# HISTORIC AND DESIGN REVIEW COMMISSION

**HDRC CASE NO:** 2024-121  
**COMMON NAME:** 217 NEWELL  
**LEGAL DESCRIPTION:** NCB 14164 (SAMUELS GLASS MARKET (IDZ), BLOCK 1 LOT 25  
**ZONING:** IDZ, RIO-2  
**CITY COUNCIL DIST.:** 1  
**APPLICANT:** Daniel Elder/Oxbow Real Estate, LLC  
**OWNER:** Daniel Elder/Oxbow Real Estate, LLC  
**TYPE OF WORK:** Construction of a pedestrian bridge across the San Antonio River  
**APPLICATION RECEIVED:** March 14, 2024  
**60-DAY REVIEW:** May 13, 2024  
**CASE MANAGER:** Edward Hall

## REQUEST:

## SOUTH BRIDGE GUARDRAIL

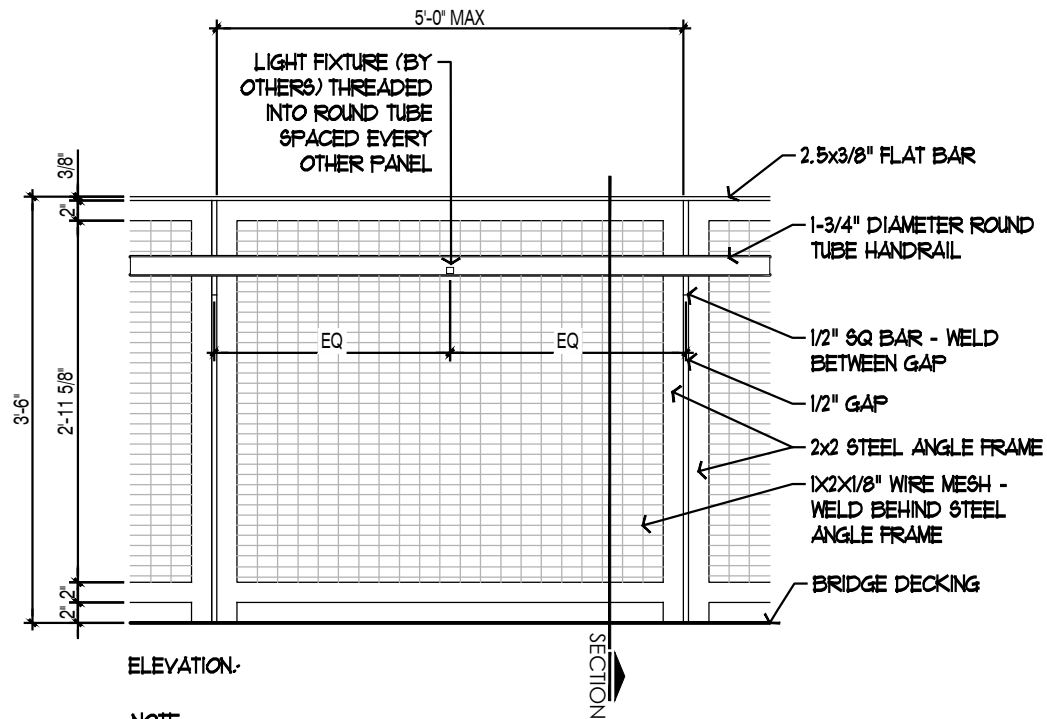
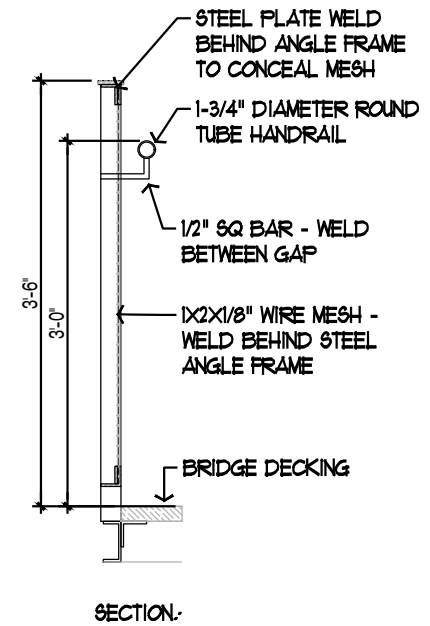
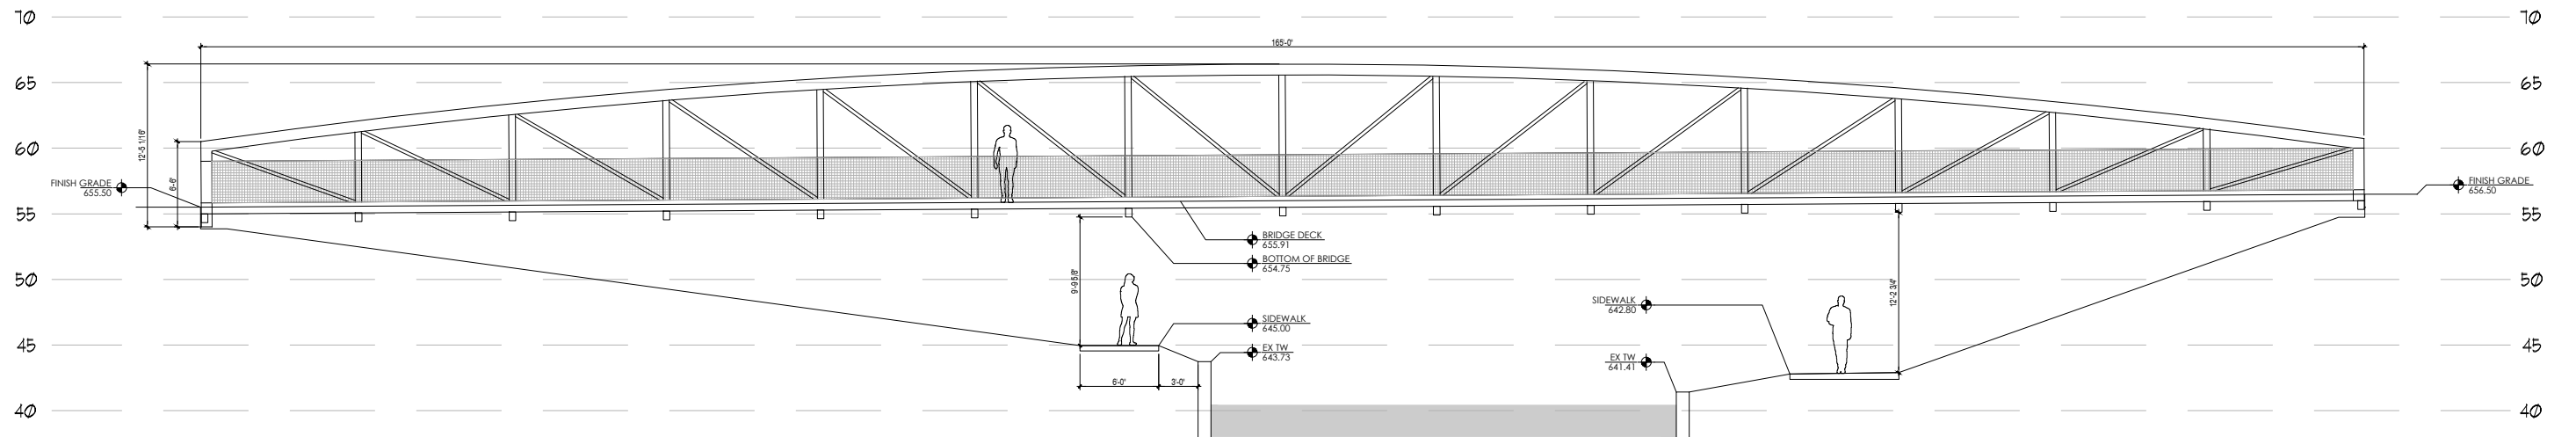
- c. PEDESTRIAN BRIDGE – The applicant has proposed for the bridge to feature an overall span of approximately 165 feet, with clearances of 9' – 10" on the west side and 12' – 3" on the east side. Staff finds this to be appropriate.

- d. PEDESTRIAN BRIDGE (Materials) – The applicant has proposed for the bridge to feature materials that include painted, steel bowstring truss design with western red cedar decking. The applicant has submitted construction documents noting the materials' specifications and installation methods. Staff finds the proposed materials to be appropriate and consistent with the UDC.
